Lywood Barn - Planning Question

Lywood Barn - Planning Question

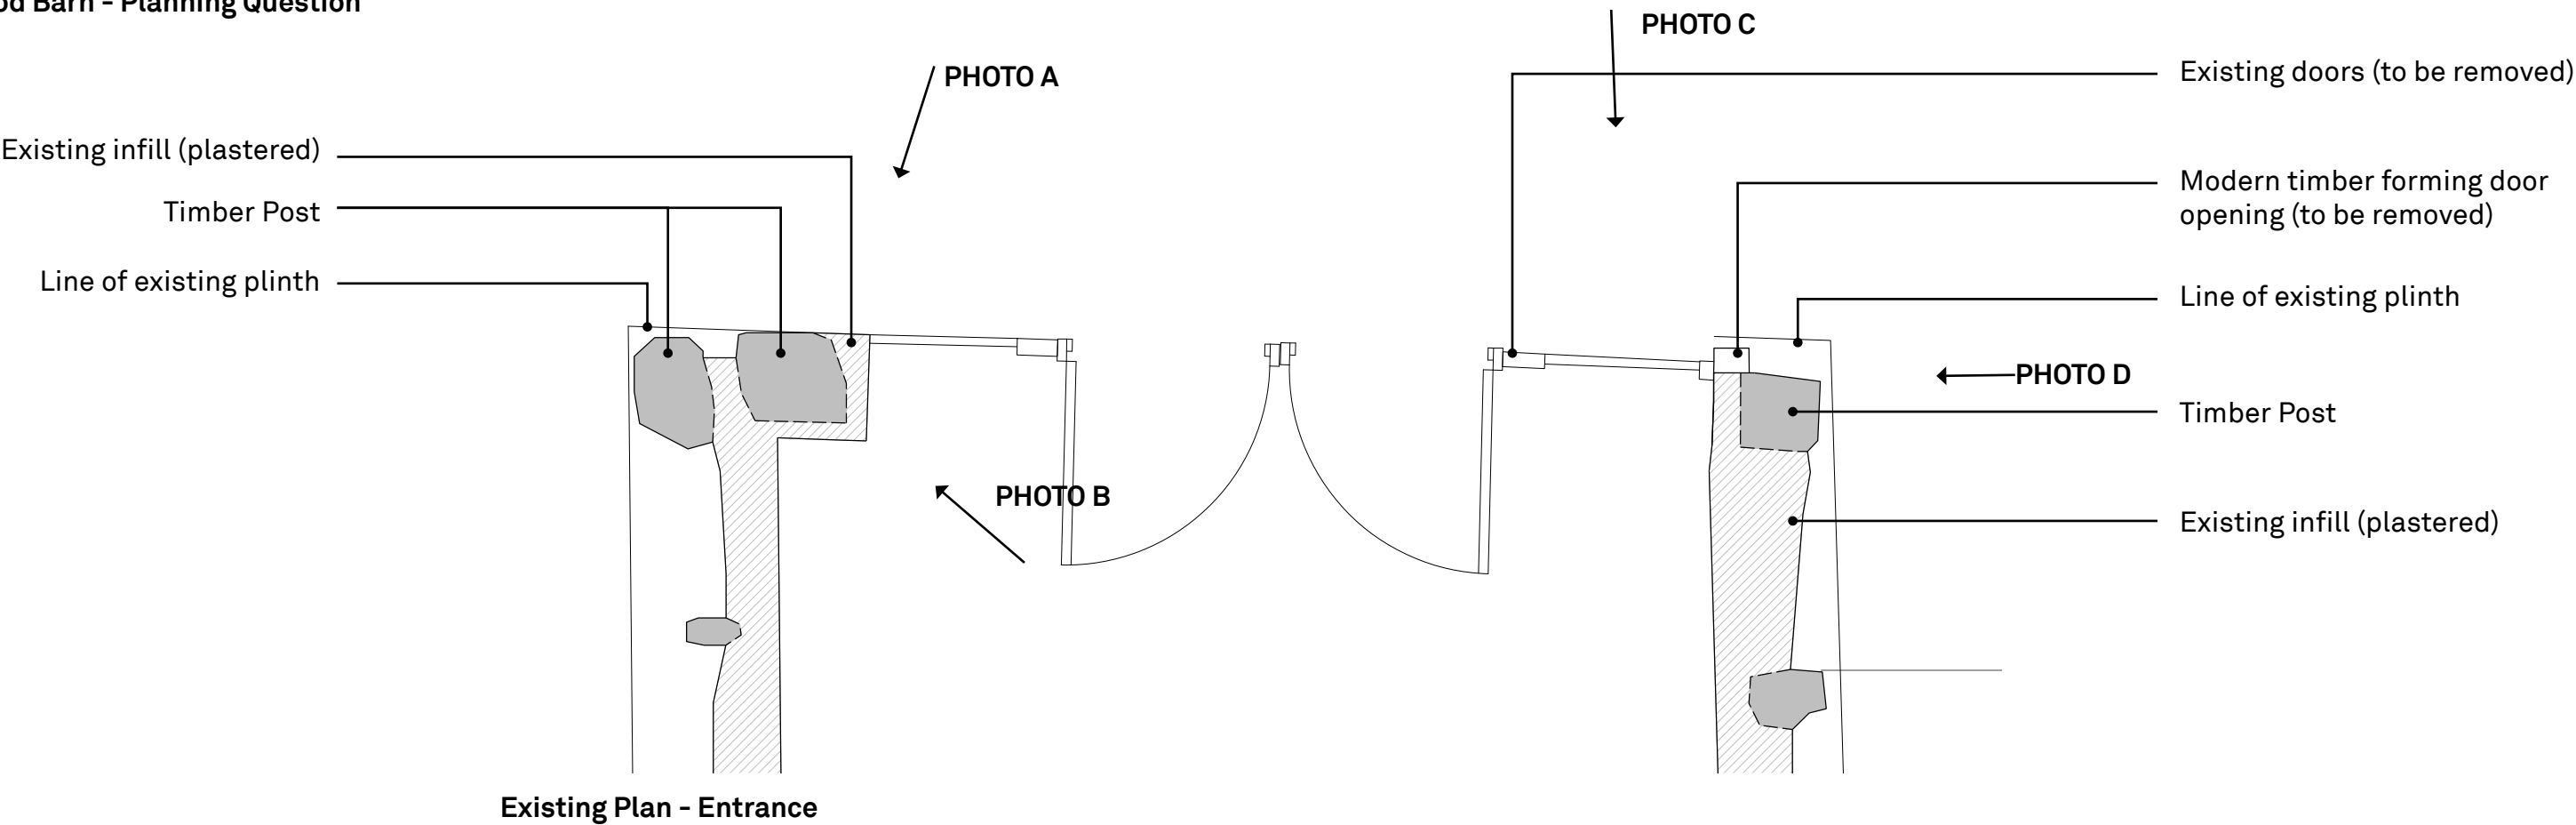
PHOTO A
Existing condition shows plaster on side adjacent to door

PHOTO B
The side of the timber post is not visible

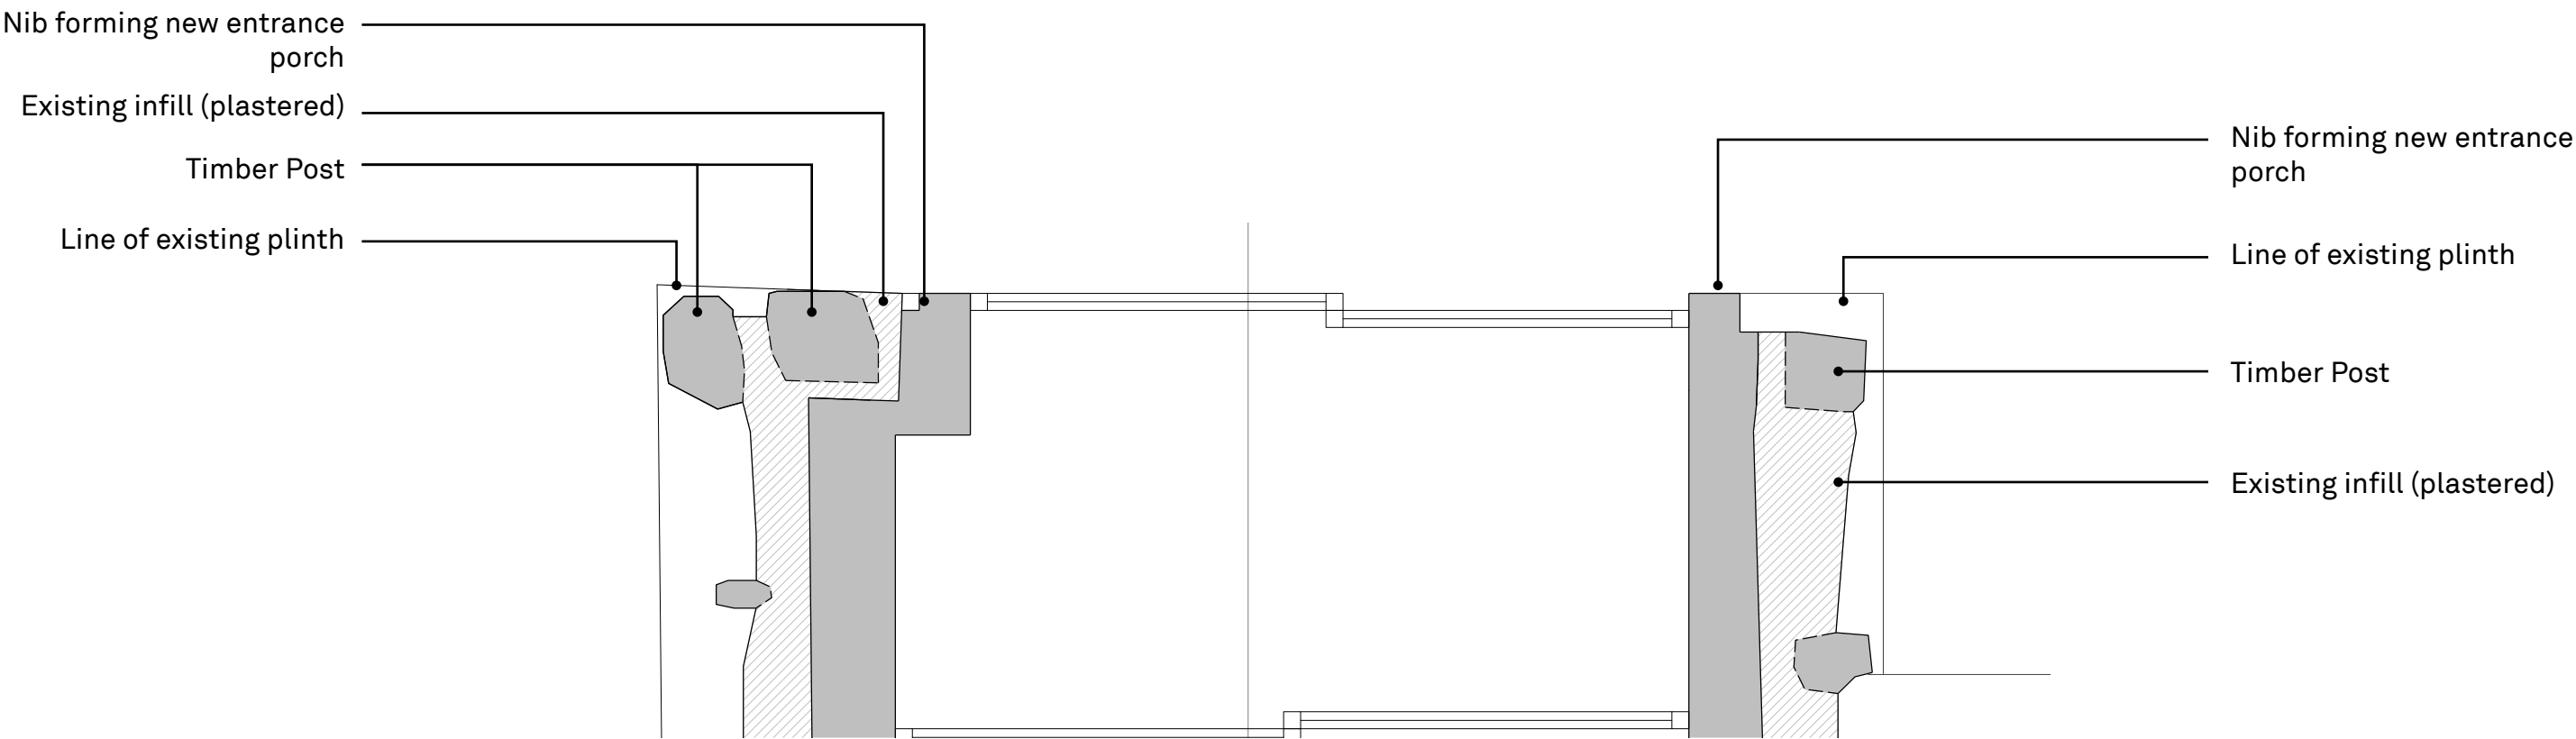
PHOTO C
Two sides of original post are visible with a modern timber fixed in front forming door opening

PHOTO D
The modern timber fixed in front of the existing post. The modern timber is to be removed.

The existing and proposed plans have been updated to give a more accurate reflection of the existing site condition. The internal articulation of the proposed porch has been amended so that it will not conceal the existing posts. The proposed nibs are set inside the existing posts so as not to obscure any view that currently exists.
